From: Bricker, Robert
Sent: Thursday, March 10, 2022 3:59 PM
To: Linda D. Alexander (lalexander@clsimail.com)
Subject: 12785 Frederick Road_Perc Cert issues
Attachments: 12785 Frederick Road_Perc Cert partial scan_comment.pdf; 12785 Frederick Road_trench specs-reissued.pdf; Suit Property_Variance for steep slope setback.pdf

RE: 12785 Frederick Road, Percolation test results and data

From: Bricker, Robert
Sent: Wednesday, August 18, 2021 4:52 PM
To: Linda D. Alexander (lalexander@clsimail.com)
Subject: 12785 Frederick Road_Margaret Suit Property
Attachments: Margaret Suit proposal_plan markups.pdf

PERC CERTIFICATION PLAN
SUIT PROPERTY
12785 FREDERICK ROAD
TAX MAP: 15 * BLOCK: 11 * PARCEL: 71
3rd ELECTION DISTRICT * HOWARD COUNTY, MD

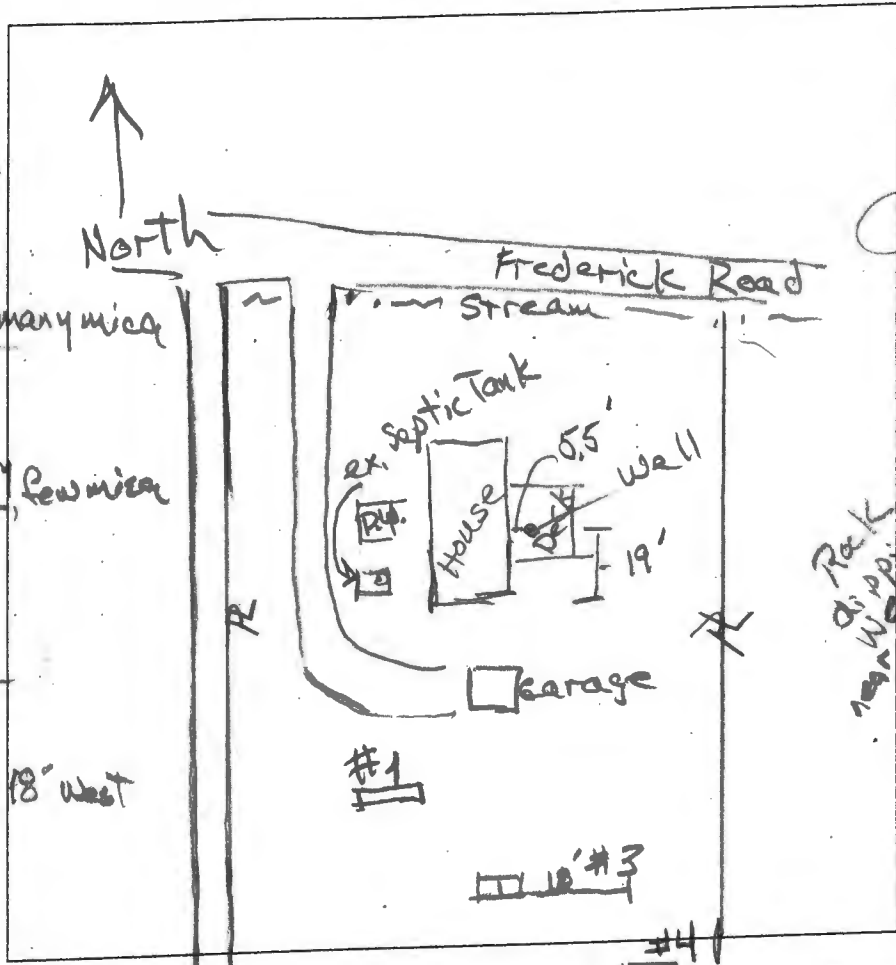
The regulated 25-ft setback from the SDA to slopes greater than 25 percent greatly affects the potential approvable area for the SDA. It may be helpful for the slopes mapped as 25 percent and greater to be confirmed in the areas nearest to the proposed SDA. The 25-foot setback does not apply to slopes of 25 percent. I do not know how accurate the LIDAR topography may be, so I have attached a photocopy of the perc plan on which I circled three areas of interest that may have slightly lesser slope than indicated.

error location 1

I recommend that the proposed well nearest the southeast property corner be located just ten feet from the south property line, and that the well location proposed nearest to the west property boundary be moved uphill several feet nearer to the back BRL.

Maximum
Potential Test
Area Ref
Existing
Conditions

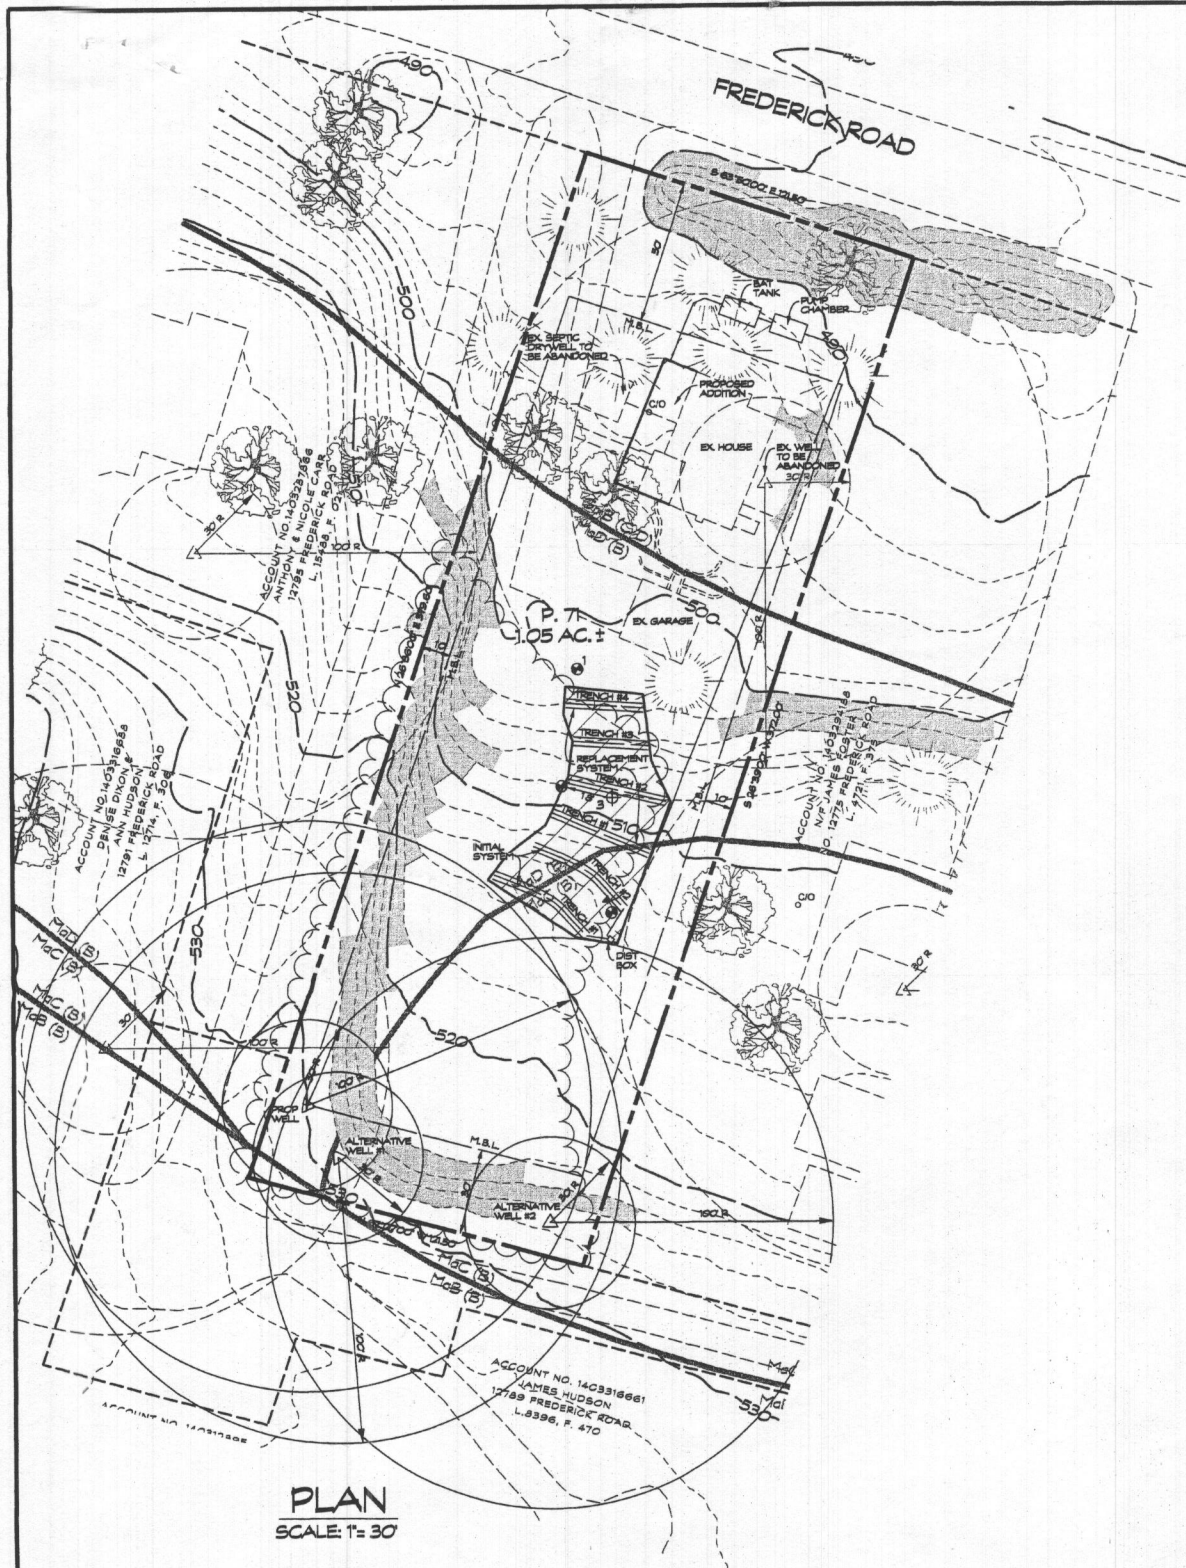
The percolation test proposal submitted to the Health Department for Margaret A Suit Property must be revised. I have attached a PDF with two mark-ups of the submitted Perc test Application Plan. One markup illustrates the area that may be considered for sewage disposal area after the 200-ft setback to a downgradient well and the 25-ft setbacks to slopes greater than 25 percent are observed. The other markup illustrates the area that may be considered for sewage disposal area if the well is re-located to the back of the property.

There was not a purpose statement on the plan or associated with the proposal in any way. We need to know have a statement of purpose.

- what is this for?
(addition, etc)

- proposed SPA upgrade
in all 2010

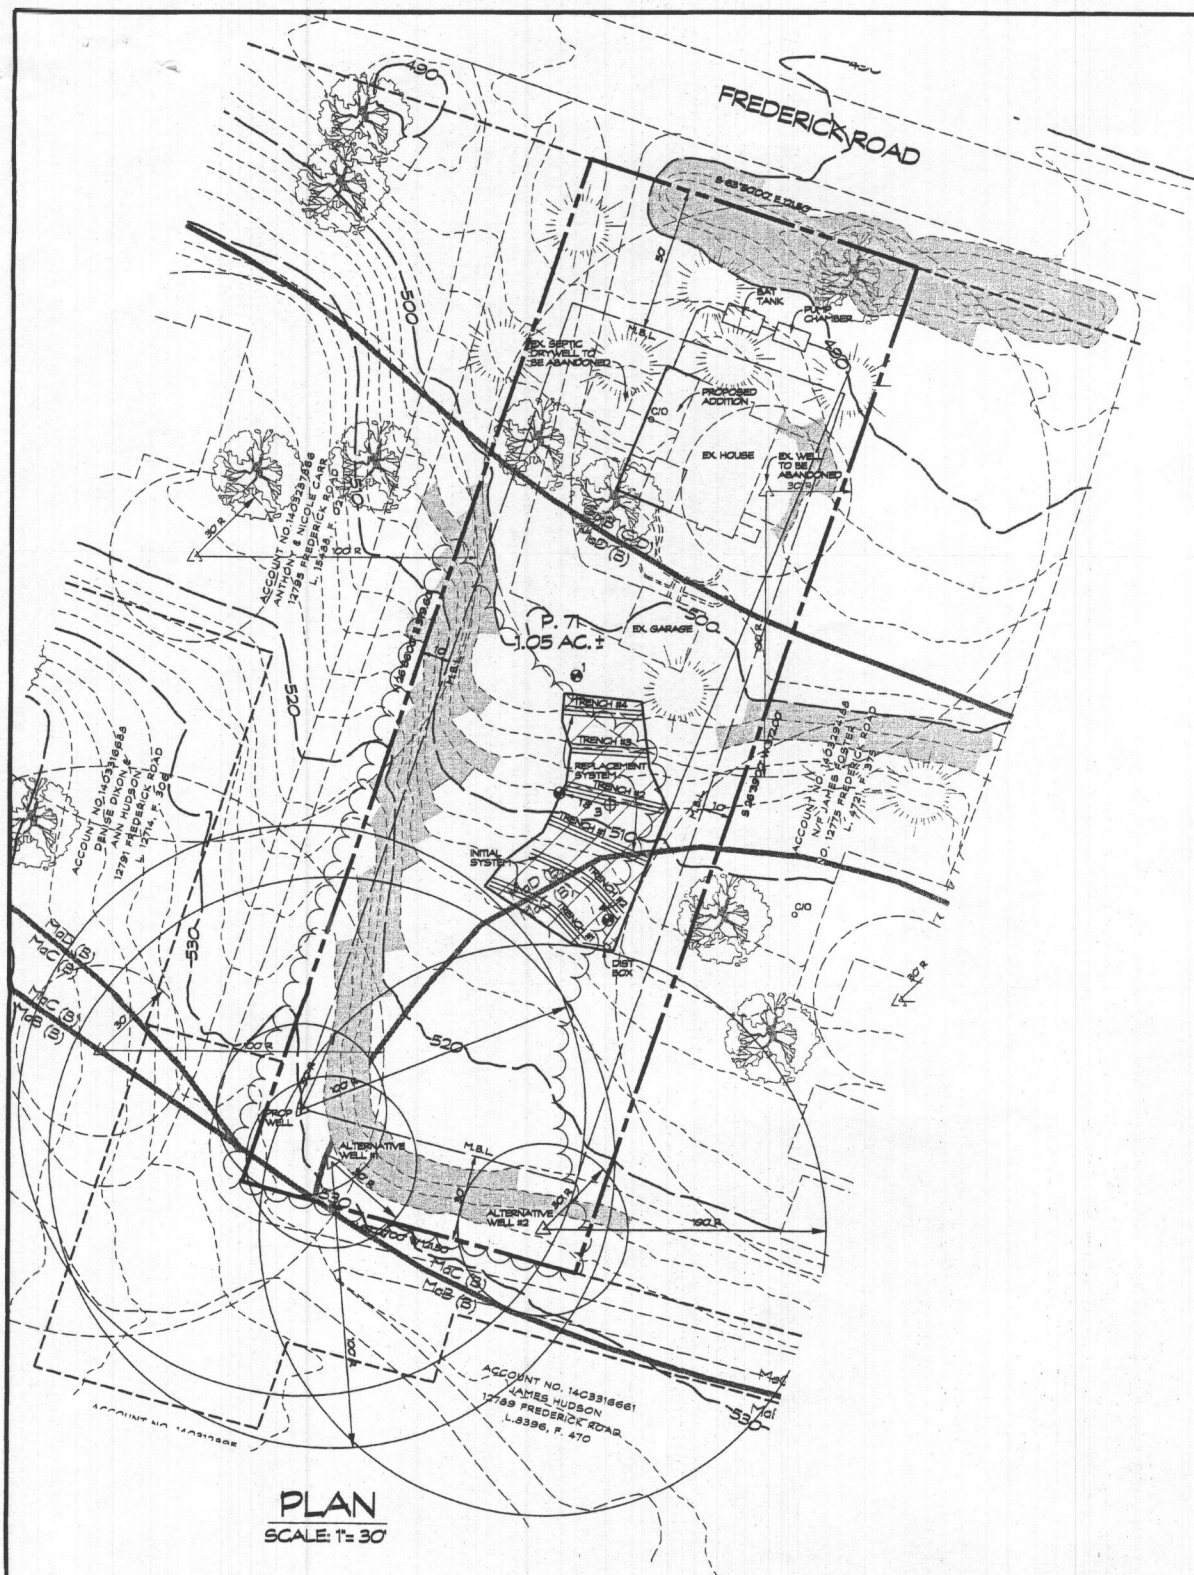
I have noticed that the Purpose Statement should be edited to clearly state the real purposes for a Percolation Certification Plan, i.e., to establish a sewage disposal area and to identify potential well locations in support of a building permit to increase the number of bedrooms in the residence.

The most recently submitted Percolation Certification Plan for 12785 Frederick Road (Suit Property) was not signed. Inadequate trench spacing for the Initial System drainfield was cited. Potential layouts for trenches have been explored and discussed within the Bureau of Environmental Health.

I am attaching a revised specifications sheet on which you will see that the condition stated for location and depth of Replacement System trenches has been withdrawn. The Replacement System should have three trenches of equal, or nearly equal, length.

I am also attaching a partial scan of the Perc Cert, on which I have marked notes to be deleted and stated trench spacing corrections.

Linda,
See attached PDF content. In the "Notes" section, two of the three notes are 'x'd out. These two notes should not be on the Percolation Certification Plan at this time. You may remove the two notes and re-submit the plan for review and potential signature approval.
